S/V BEATRIX - KELLY-PETERSON 44	TITLE	REV	SCALE	PAGE	DATE	DRAWN BY
#286 (1980)	Fresh Water Plumbing - Aft Head	В	1: 1	1 OF 4	7/23/2007	JSTANDER

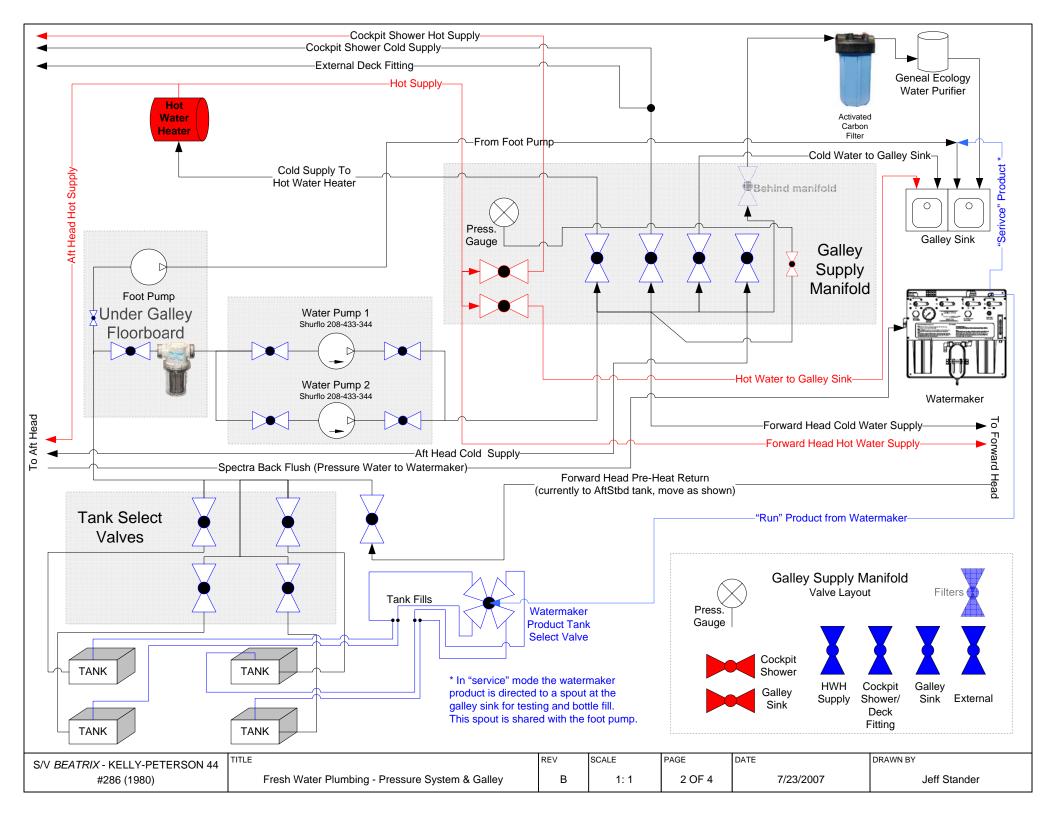
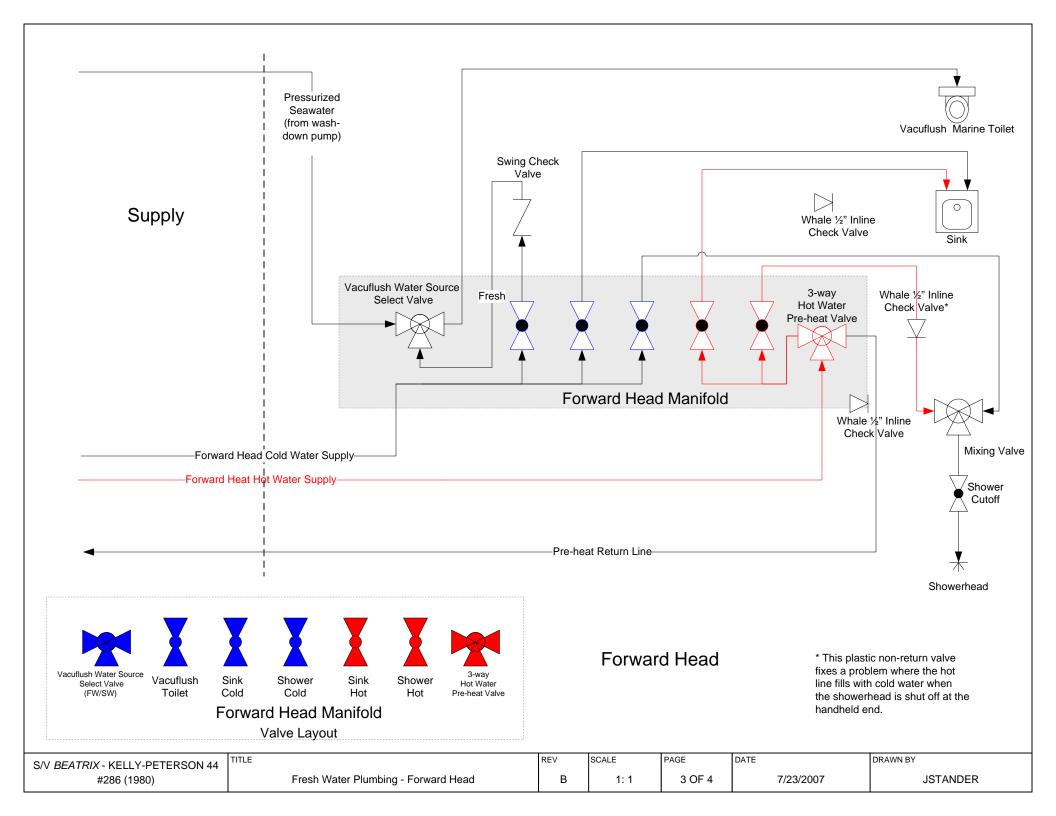
- 1. Move accumulator or accumulator line closer to pump.
- 2. Make a "clean" compartment for cockpit shower hose, i.e. baffle or reroute other hoses because it gets hung up on them.
- 4. Final hookup so hot water heater does not share supply line with aft head. (I think this is done)
